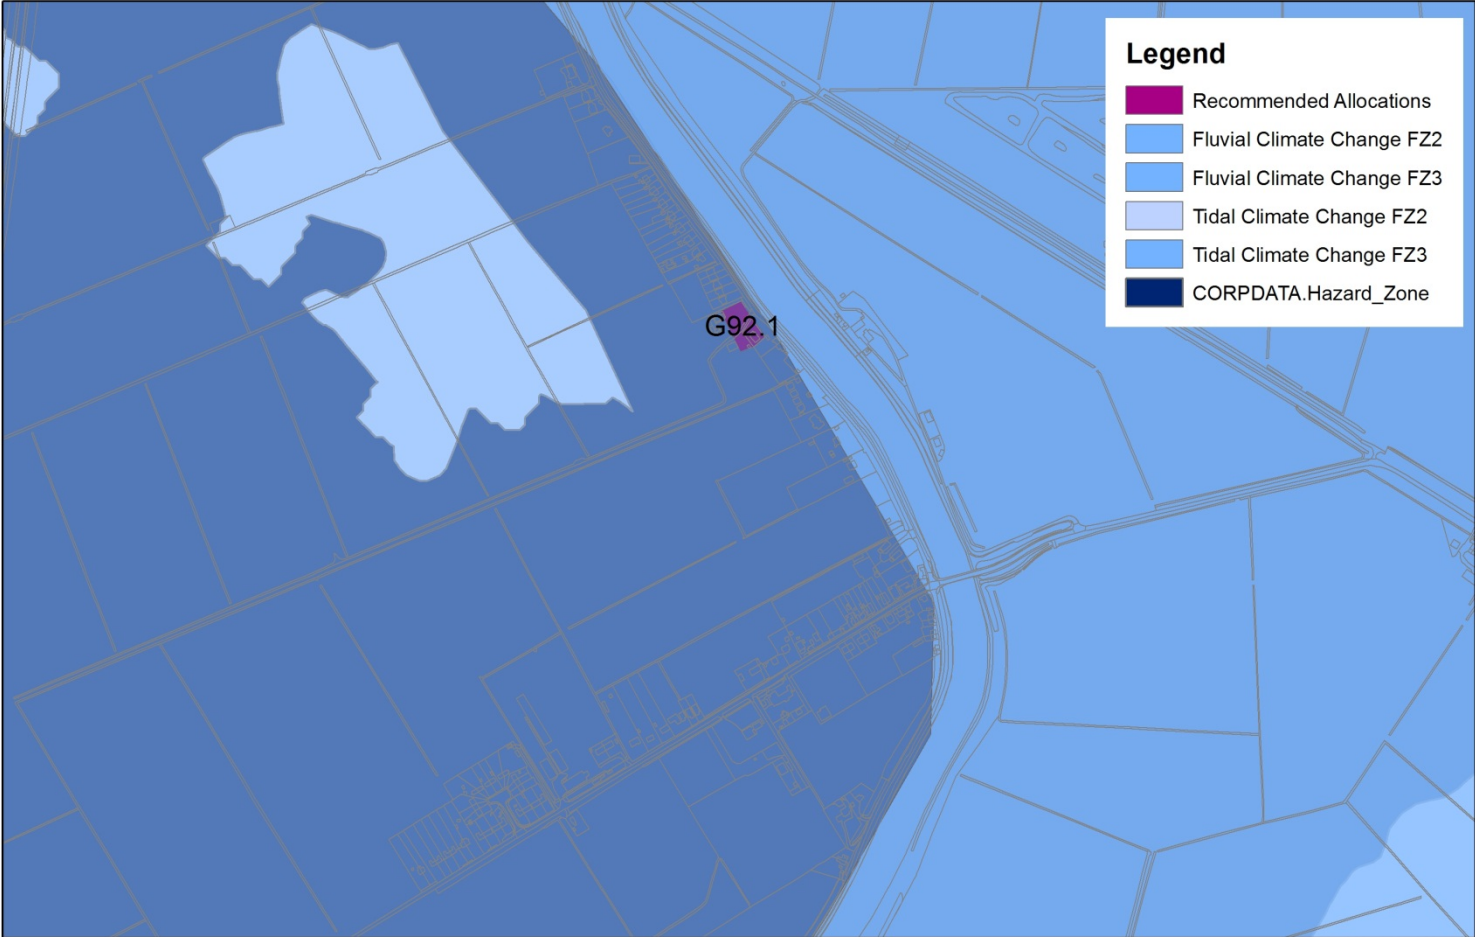
Flood Risk	Statutory consultee comments	Flood Risk - Noted in the Sustainability Appraisal	Council's Approach in the proposed SADMP policy
<p>Flood Zone 3 & Hazard Zone</p>	<p>Miss Emily Crook (ID: 476133), The Environment Agency:</p> <ul style="list-style-type: none"> We have reviewed the draft allocations set out within Section G and have no objection. We consider that flood risk to these sites can be adequately addressed at full planning stage by the application of draft policy DM21 (Sites in Areas of Flood Risk). 	<p>'xx' The site performs poorly on 'flood risk' (flood zone 3) although this factor constrains the whole settlement.</p>	<ul style="list-style-type: none"> Submission of a Flood Risk Assessment (FRA) that should address all forms of flood risk (coastal inundation, fluvial, pluvial and groundwater). The FRA should explain how surface water drainage will be managed. The FRA must demonstrate how the development would provide wider sustainability benefits to the community that outweigh the risk associated with flooding and that the development would be safe for its lifetime without increasing flood risk elsewhere and, where possible, would reduce flood risk overall. The FRA should also suggest appropriate mitigation (flood resiliency measures) Submission of details showing how sustainable drainage measures will be incorporated into the development to avoid discharge to the public surface water network, and also to the amenity and biodiversity of the development. A suitable plan for the future management and maintenance of the Sustainable Drainage System (SUDS) should be included with the submission

Terrington St. Clement

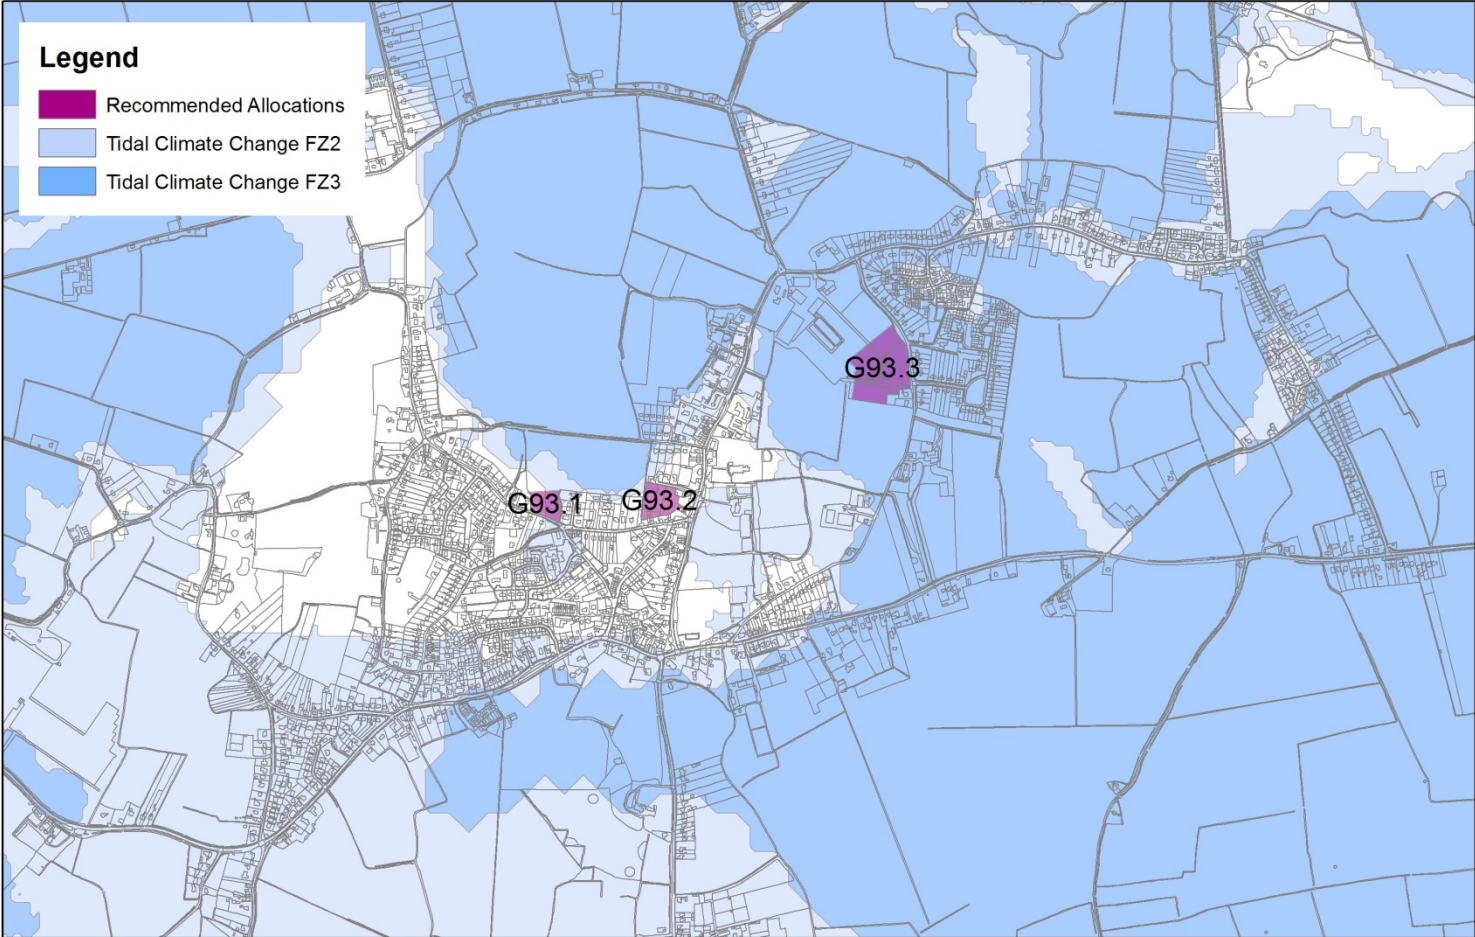
Flood Risk	Statutory consultee comments	Flood Risk - Noted in the Sustainability Appraisal	Council's Approach in the proposed SADMP policy
Partial Flood Zone 2	<p>Miss Emily Crook (ID: 476133), The Environment Agency:</p> <ul style="list-style-type: none"> We have reviewed the draft allocations set out within Section G and have no objection. We consider that flood risk to these sites can be adequately addressed at full planning stage by the application of draft policy DM21 (Sites in Areas of Flood Risk). 	<p>'+/x' Also in comparison to other parts of site 539, the site is in a lesser degree of flood risk (partly in flood zone 2 and partly in flood zone 1).</p>	<ul style="list-style-type: none"> Submission of a Flood Risk Assessment (FRA) that should address all forms of flood risk (coastal inundation, fluvial, pluvial and groundwater). The FRA should explain how surface water drainage will be managed. The FRA must demonstrate how the development would provide wider sustainability benefits to the community that outweigh the risk associated with flooding and that the development would be safe for its lifetime without increasing flood risk elsewhere and, where possible, would reduce flood risk overall. The FRA should also suggest appropriate mitigation (flood resiliency measures)

Flood Risk	Statutory consultee comments	Flood Risk - Noted in the Sustainability Appraisal	Council's Approach in the proposed SADMP policy
Partial Flood Zone 2	<p>Miss Emily Crook (ID: 476133), The Environment Agency:</p> <ul style="list-style-type: none"> We have reviewed the draft allocations set out within Section G and have no objection. We consider that flood risk to these sites can be adequately addressed at full planning stage by the application of draft policy DM21 (Sites in Areas of Flood Risk). 	<p>'+/x' The site is mostly in a low flood risk area (FZ1) with a very small section on the north-west corner subject to medium flood risk (FZ2).</p>	<ul style="list-style-type: none"> Proposed minor modification: Submission of a Flood Risk Assessment (FRA) that should address all forms of flood risk (coastal inundation, fluvial, pluvial and groundwater). The FRA should explain how surface water drainage will be managed. The FRA must demonstrate how the development would provide wider sustainability benefits to the community that outweigh the risk associated with flooding and that the development would be safe for its lifetime without increasing flood risk elsewhere and, where possible, would reduce flood risk overall. The FRA should also

Flood Risk	Statutory consultee comments	Flood Risk - Noted in the Sustainability Appraisal	Council's Approach in the proposed SADMP policy
			suggest appropriate mitigation (flood resiliency measures)

Flood Risk	Statutory consultee comments	Flood Risk - Noted in the Sustainability Appraisal	Council's Approach in the proposed SADMP policy
Partial Flood Zone 2	<p>Miss Emily Crook (ID: 476133), The Environment Agency:</p> <ul style="list-style-type: none"> We have reviewed the draft allocations set out within Section G and have no objection. We consider that flood risk to these sites can be adequately addressed at full planning stage by the application of draft policy DM21 (Sites in Areas of Flood Risk). 	<p>'xx' The site is subject to high flood risk (FZ3).</p> <p>Site G93.3 falls within FZ3 (high flood risk area). However based on the benefits of the site, the constraints associated with the other site options that are in a lower degree of flood risk, and the need for growth in the settlement, it is considered that on balance the benefits of allocating the site outweighs this constraint. However, development is subject to the appropriate flood mitigation measures as set out in the flood risk policy.</p>	<ul style="list-style-type: none"> Submission of a Flood Risk Assessment (FRA) that should address all forms of flood risk (coastal inundation, fluvial, pluvial and groundwater). The FRA should explain how surface water drainage will be managed. The FRA must demonstrate how the development would provide wider sustainability benefits to the community that outweigh the risk associated with flooding and that the development would be safe for its lifetime without increasing flood risk elsewhere and, where possible, would reduce flood risk overall. The FRA should also suggest appropriate mitigation (flood resiliency measures)

Terrington St John, St John's Highway and Tilney St Lawrence

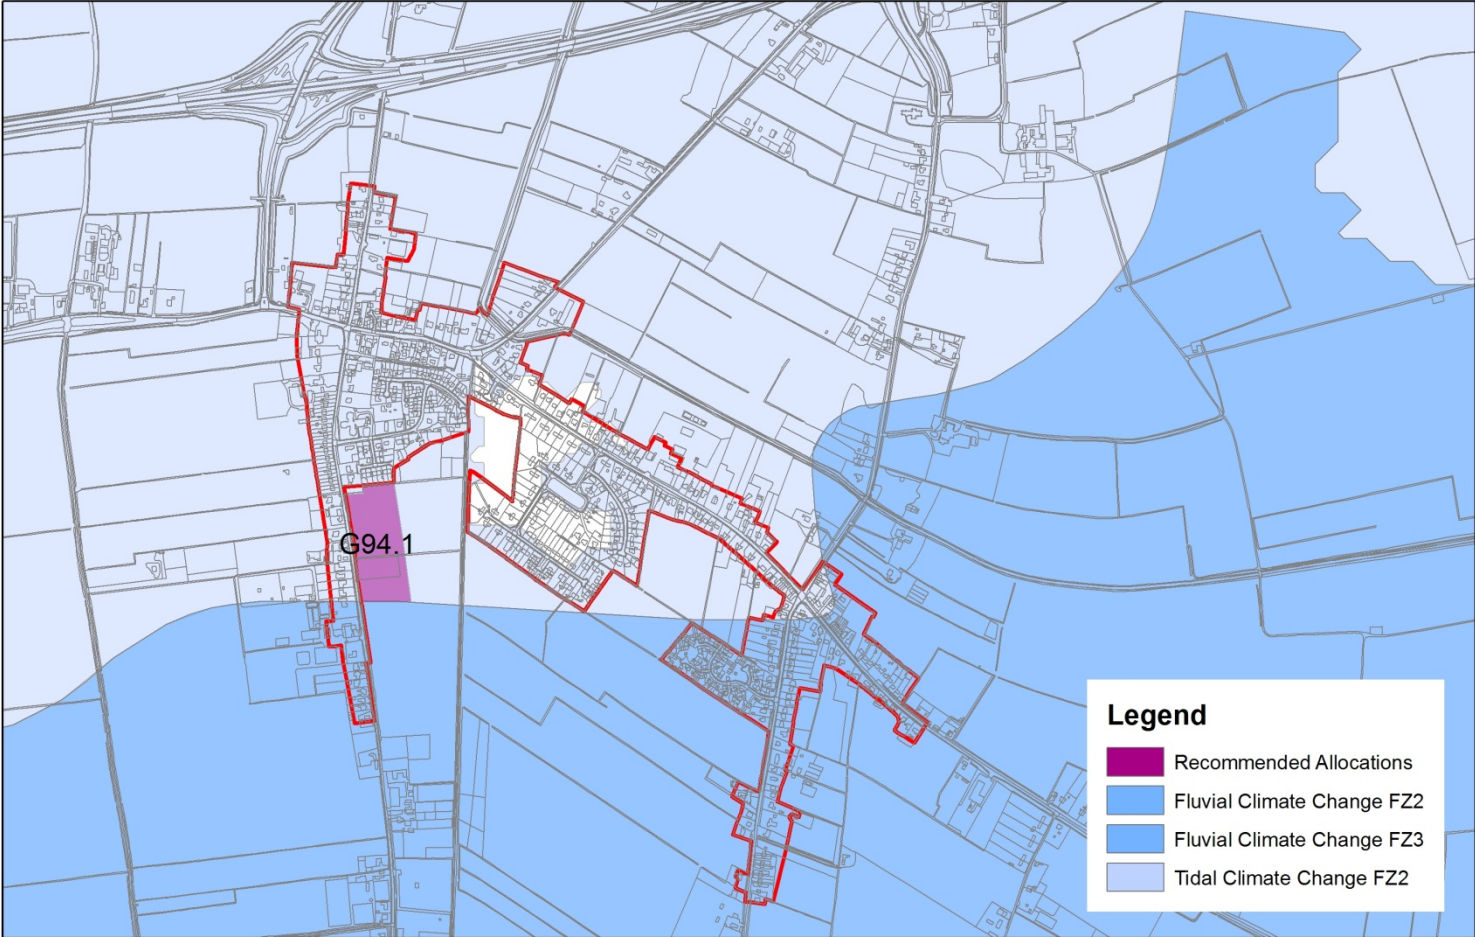
Flood Risk	Statutory consultee comments	Flood Risk - Noted in the Sustainability Appraisal	Council's Approach in the proposed SADMP policy
Flood Zone 2	<p>Miss Emily Crook (ID: 476133), The Environment Agency:</p> <ul style="list-style-type: none"> • We have reviewed the draft allocations set out within Section G and have no objection. We consider that flood risk to these sites can be adequately addressed at full planning stage by the application of draft policy DM21 (Sites in Areas of Flood Risk). 	<p>'x' The site is within flood zone 2 (medium flood risk)</p>	<ul style="list-style-type: none"> • Submission of a Flood Risk Assessment (FRA) that should address all forms of flood risk (coastal inundation, fluvial, pluvial and groundwater). The FRA should explain how surface water drainage will be managed. The FRA must demonstrate how the development would provide wider sustainability benefits to the community that outweigh the risk associated with flooding and that the development would be safe for its lifetime without increasing flood risk elsewhere and, where possible, would reduce flood risk overall. The FRA should also suggest appropriate mitigation (flood resiliency measures) • Submission of details showing how sustainable drainage measures will be incorporated into the development to avoid discharge to the public surface water network, and also to the amenity and biodiversity of the development. A suitable plan for the future management and maintenance of the Sustainable Drainage System (SUDS) should be included with the submission

Three Holes

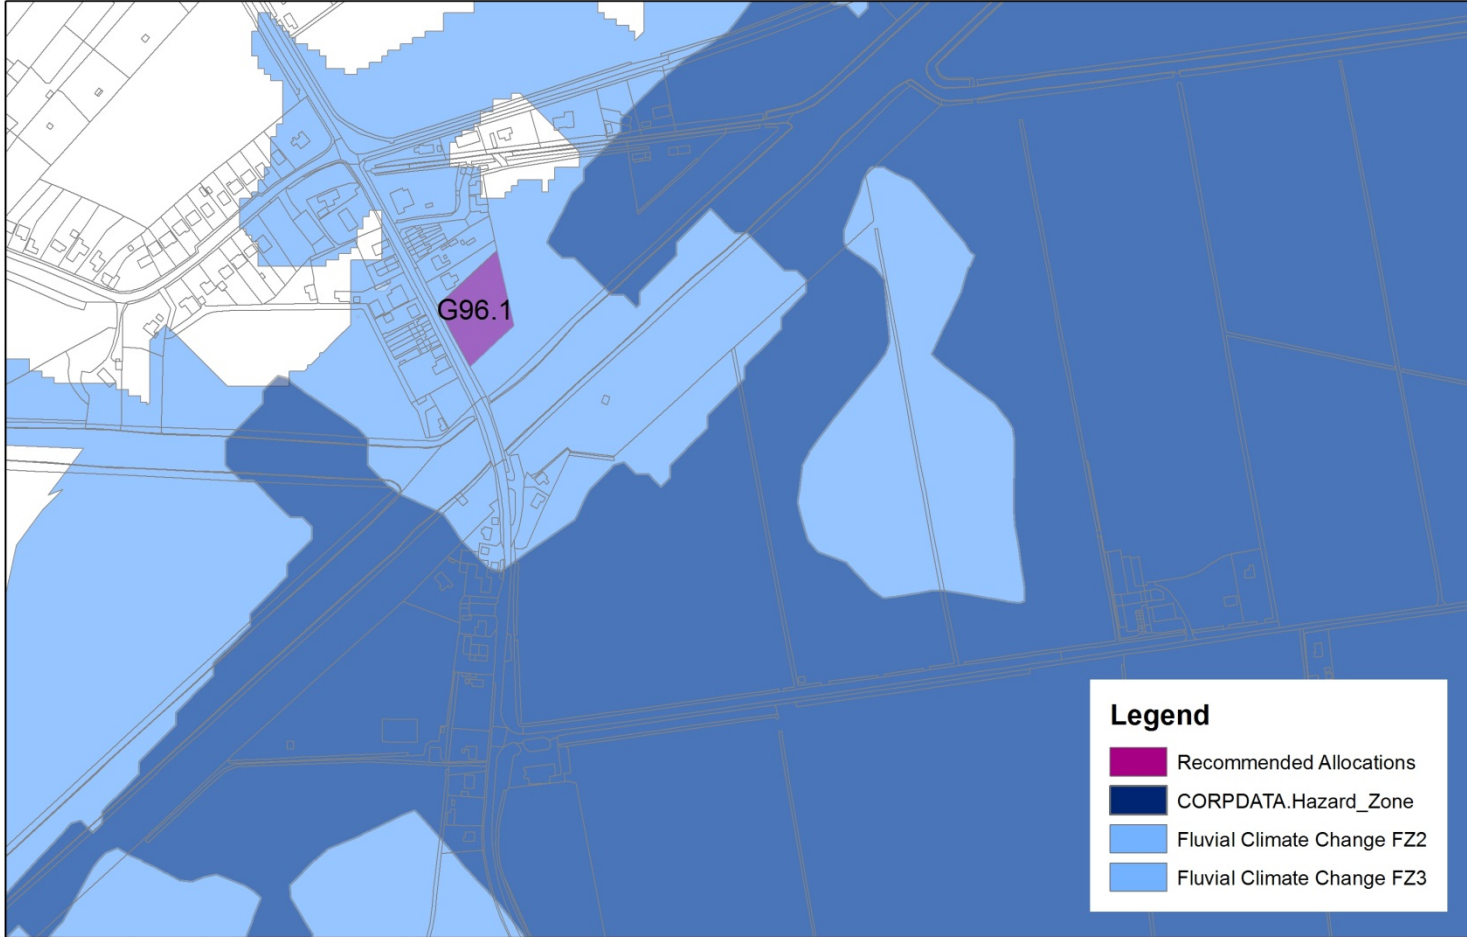
Flood Risk	Statutory consultee comments	Flood Risk - Noted in the Sustainability Appraisal	Council’s Approach in the proposed SADMP policy	Agent Comments
<p>Flood Zone 3</p>	<p>Miss Emily Crook (ID: 476133), The Environment Agency:</p> <ul style="list-style-type: none"> We have reviewed the draft allocations set out within Section G and have no objection. We consider that flood risk to these sites can be adequately addressed at full planning stage by the application of draft policy DM21 (Sites in Areas of Flood Risk). <p>Graham Moore (ID: 138584) , Middle Level Commissioners :</p> <ul style="list-style-type: none"> Consider that five dwellings meeting current standards and the Board’s requirements without increasing flood risk may be non-technically viable or deliverable at this location. 	<p>‘xx’ The site performs poorly in relation to the indicator ‘flood risk’ however this is the same for all of growth site options.</p>	<ul style="list-style-type: none"> Submission of a Flood Risk Assessment (FRA) that should address all forms of flood risk (coastal inundation, fluvial, pluvial and groundwater). The FRA should explain how surface water drainage will be managed. The FRA must demonstrate how the development would provide wider sustainability benefits to the community that outweigh the risk associated with flooding and that the development would be safe for its lifetime without increasing flood risk elsewhere and, where possible, would reduce flood risk overall. The FRA should also suggest appropriate mitigation (flood resiliency measures) Submission of details showing how sustainable drainage measures will be incorporated into the development to avoid discharge to the public surface water network, and also to the amenity and biodiversity of the development. A suitable plan for the future management and maintenance of the Sustainable Drainage System (SUDS) should be included with the submission 	<ul style="list-style-type: none"> Agent is aware that recent developments within the area of similar soil types have been developed successfully and viably without particular issue. The agent concludes, that having taken note of the MLC comments, they are satisfied that there are no drainage implications of the development which cannot be satisfactorily addressed. Further to this the agent (Appendix 1) has consulted with water and drainage engineers who detail an anticipated method of drainage. With discharge being restricted to greenfield runoff rate and due to the low density of the development that space is available to accommodate the drainage system.

Flood Risk	Statutory consultee comments	Flood Risk - Noted in the Sustainability Appraisal	Council's Approach in the proposed SADMP policy	Agent Comments
			<ul style="list-style-type: none"> The detail of the scheme can be developed in consultation with Norfolk County Council, as the Lead Local Flood Authority, and the Middle Level Commissioners at the design process stage that would inform a detailed planning application

Tilney All Saints

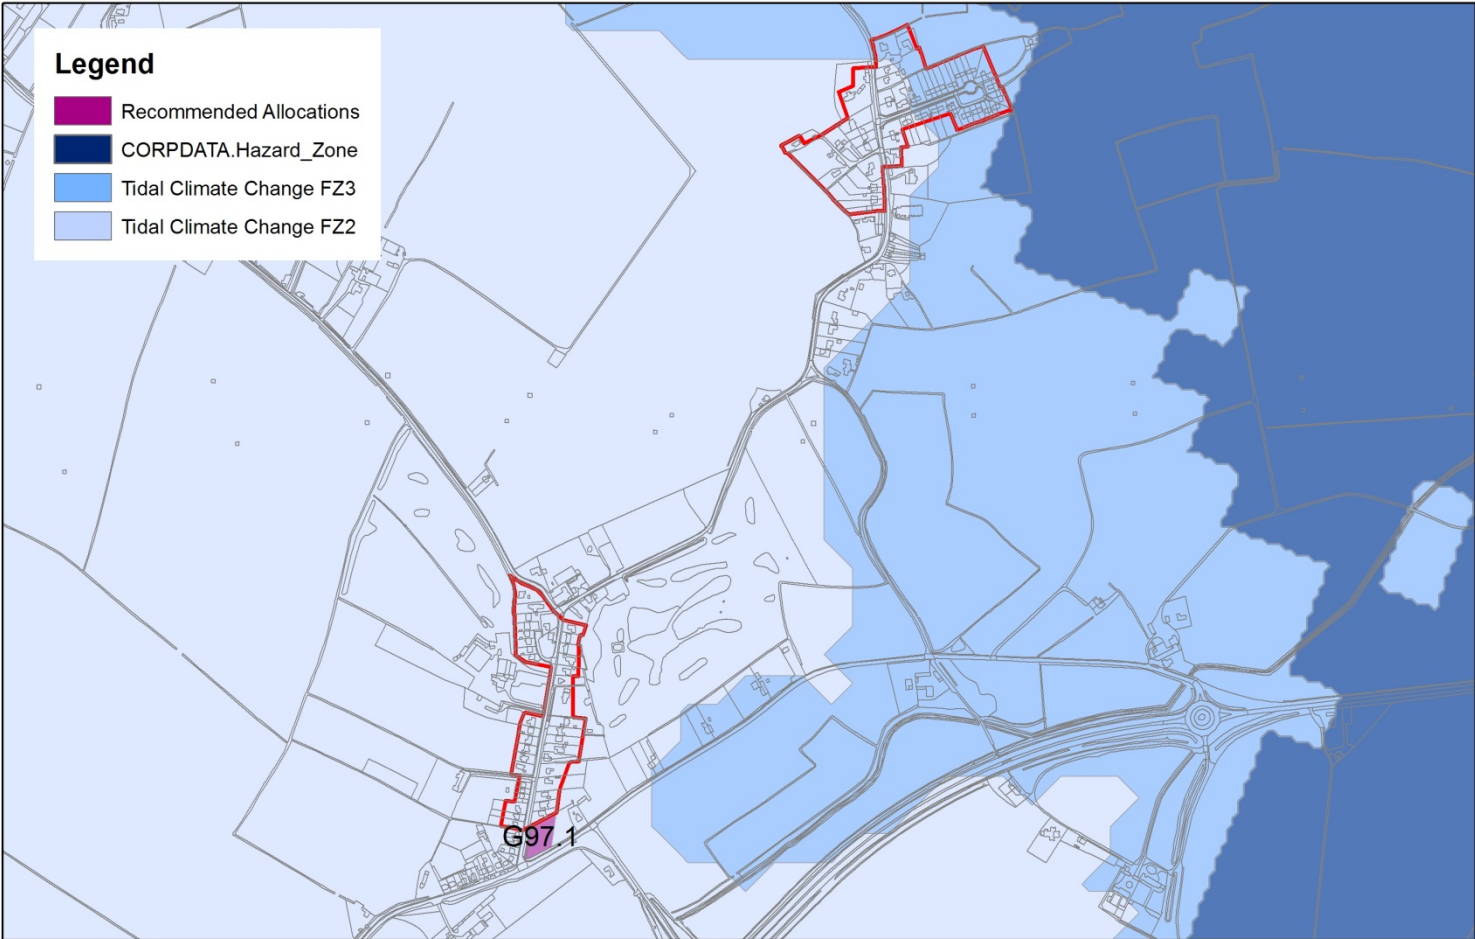
Flood Risk	Statutory consultee comments	Flood Risk - Noted in the Sustainability Appraisal	Council's Approach in the proposed SADMP policy
<p>Flood Zone 2</p>	<p>Miss Emily Crook (ID: 476133), The Environment Agency:</p> <ul style="list-style-type: none"> We have reviewed the draft allocations set out within Section G and have no objection. We consider that flood risk to these sites can be adequately addressed at full planning stage by the application of draft policy DM21 (Sites in Areas of Flood Risk). <p>Mrs Stella Kaye (ID: 877483) , Tilney All Saints Parish Council:</p> <ul style="list-style-type: none"> Raises concerns regarding drainage issues 	<p>'x' The site is in a medium flood risk area (flood zone 2).</p>	<ul style="list-style-type: none"> Submission of a Flood Risk Assessment (FRA) that should address all forms of flood risk (coastal inundation, fluvial, pluvial and groundwater). The FRA should explain how surface water drainage will be managed. The FRA must demonstrate how the development would provide wider sustainability benefits to the community that outweigh the risk associated with flooding and that the development would be safe for its lifetime without increasing flood risk elsewhere and, where possible, would reduce flood risk overall. The FRA should also suggest appropriate mitigation (flood resiliency measures) Submission of details showing how sustainable drainage measures will be incorporated into the development to avoid discharge to the public surface water network, and also to the amenity and biodiversity of the development. A suitable plan for the future management and maintenance of the Sustainable Drainage System (SUDS) should be included with the submission
